Report: Issue Data
Function: Test, Adjust, & Balance
Date: 12/04/2025
Completed By: National TAB

PROJECT
CW 8950 - Mr Cooper (Coppell, TX)

Project: CW 8950 - Mr Cooper (Coppell, TX)

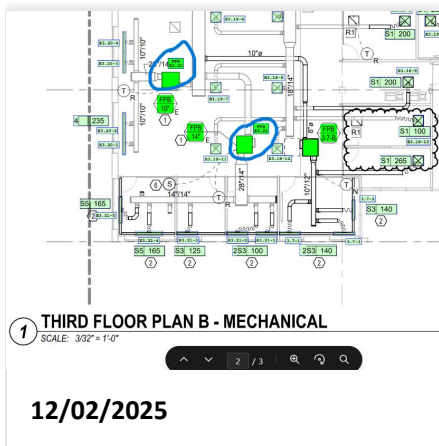
Issue Name : FPB-E3.20 Control Issue
Description : FPB-E3.20(FPB3-46 on controls graphics) does not pull up the right box when opened on control graphics. Box is labeled as FPB3-46 on control graphics, however it opens box FPB3-47. The only way to access the correct box is to go through the RTU matrix page.

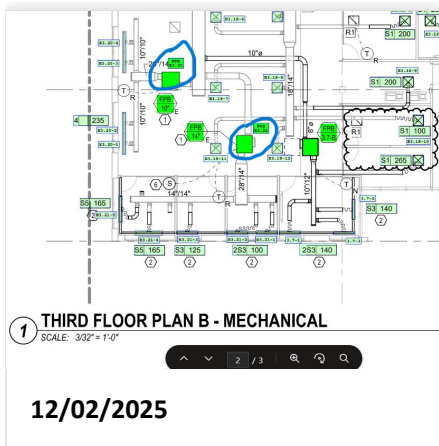
Issue Name : FPB-E3.21 Control Issue
Description : FPB-E3.21(FPB3-45 on controls graphics) does not pull up the right box when opened on control graphics. Box is labeled as FPB3-45 on control graphics, however it opens box FPB2-18. The only way to access the correct box is to go through the RTU matrix page.
Created By : National TAB **Assigned To :** National TAB - Stephan Gabbert
Status : Open
Priority : InfoOnly **Asset Tag :**
Originated Date : 12/02/2025 - Bayley Morvant - National TAB

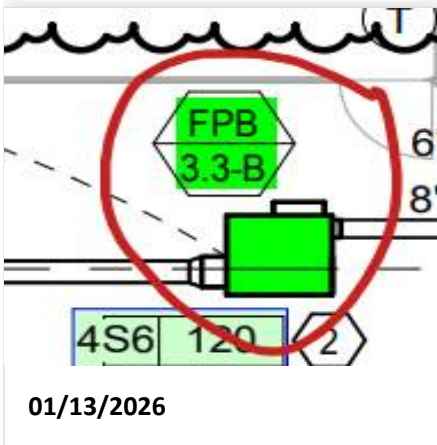
Issue Name : FPB3.3-B Primary Air Damper Not Functional
Description : Unit motorized primary air damper is not functioning correctly. Damper stays in closed position even though box is at 0 cfm and is calling for design of 500 cfm. Unable to calibrate and balance box until this is addressed.
Created By : National TAB **Assigned To :** National TAB - Stephan Gabbert
Status : Open
Priority : Urgent **Asset Tag :**
Originated Date : 01/13/2026 - Bayley Morvant - National TAB

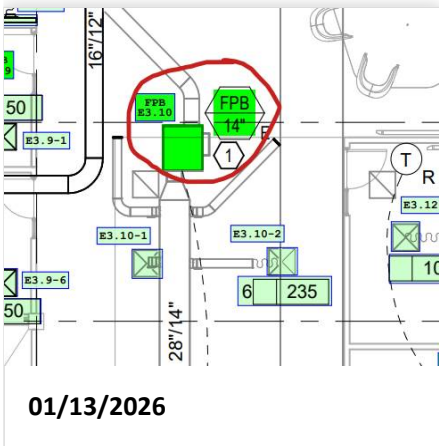
Issue Name : FPBE3-10 Fan Not Operational
Description : Fan not operational during time of testing. Unit is an existing box. (controls label is FPB3-38)
Created By : National TAB **Assigned To :** National TAB - Stephan Gabbert
Status : Open
Priority : **Urgent** **Asset Tag :**
Originated Date : 01/13/2026 - Bayley Morvant - National TAB

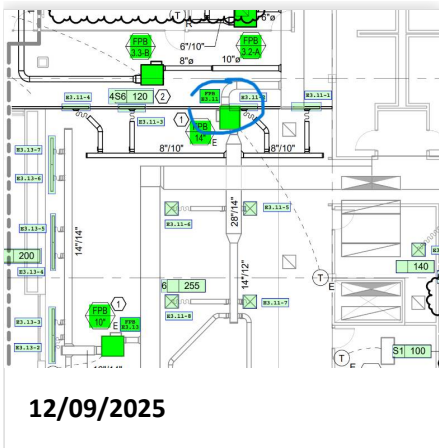
Issue Name : FPBE3-11 Fan Not Operational
Description : FPB3E3-11 fan is not operational. Unit is an existing box. (Controls label is FPB3-51)
Created By : National TAB **Assigned To :** National TAB - Stephan Gabbert
Status : Open
Priority : **Urgent** **Asset Tag :**
Originated Date : 12/09/2025 - Bayley Morvant - National TAB

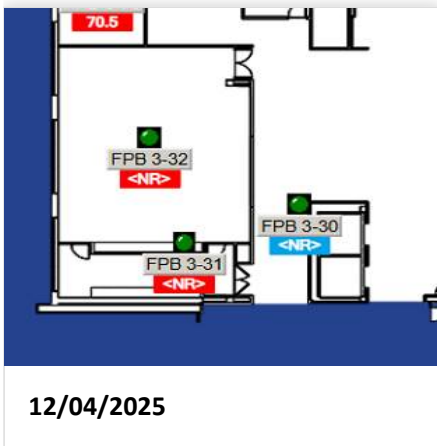
Issue Name : FPBE3.1 Showing "NR" on Controls
Description : FPBE3.1 is showing "NR" on controls. Unit is not operational. (Box labeled as FPB3-32 on controls)
Created By : National TAB **Assigned To :** National TAB - Stephan Gabbert
Status : Open
Priority : Urgent **Asset Tag :**
Originated Date : 12/04/2025 - Bayley Morvant - National TAB

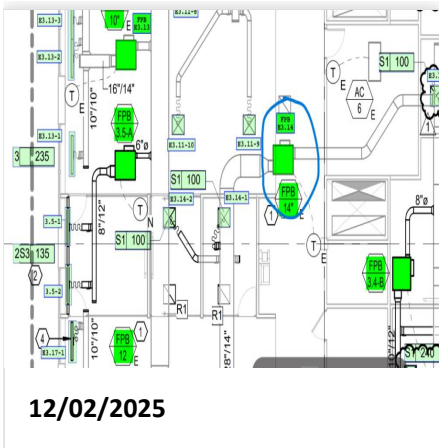
Issue Name : FPBE3.14 Fan not operational
Description : Fan not operational during time of testing. Unit is existing box. (box labeled as FPB3-48 on controls graphics)
Created By : National TAB **Assigned To :** National TAB - Stephan Gabbert
Status : Open
Priority : **Urgent** **Asset Tag :**
Originated Date : 12/02/2025 - Bayley Morvant - National TAB

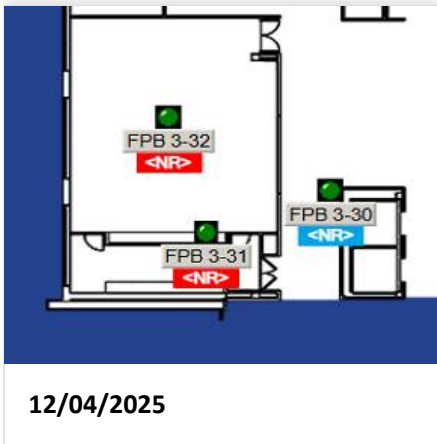
Issue Name : FPBE3.2 Showing "NR" on Controls
Description : FPBE3.2 is showing "NR" on controls. Box is not operational. (Box labeled as FPB3-31 on controls)
Created By : National TAB **Assigned To :** National TAB - Stephan Gabbert
Status : Open
Priority : Urgent **Asset Tag :**
Originated Date : 12/04/2025 - Bayley Morvant - National TAB

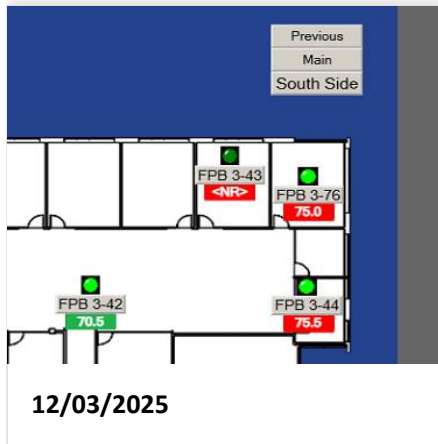
Issue Name : FPBE3.23 Showing "NR" on Controls
Description : FPBE3.23 is showing "NR" on controls. Unable to control box to calibrate and balance. (Controls name for thie box is FPB3-43)
Created By : National TAB **Assigned To :** National TAB - Stephan Gabbert
Status : Open
Priority : Urgent **Asset Tag :**
Originated Date : 12/03/2025 - Bayley Morvant - National TAB

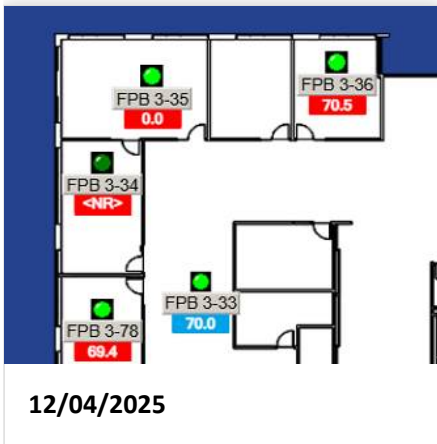
Issue Name : FPBE3.4 Showing "NR" on Controls
Description : FPBE3.4 is showing "NR" on controls and is not operational. (Box labeled as FPB3-34 on controls graphics)
Created By : National TAB **Assigned To :** National TAB - Stephan Gabbert
Status : Open
Priority : Urgent **Asset Tag :**
Originated Date : 12/04/2025 - Bayley Morvant - National TAB
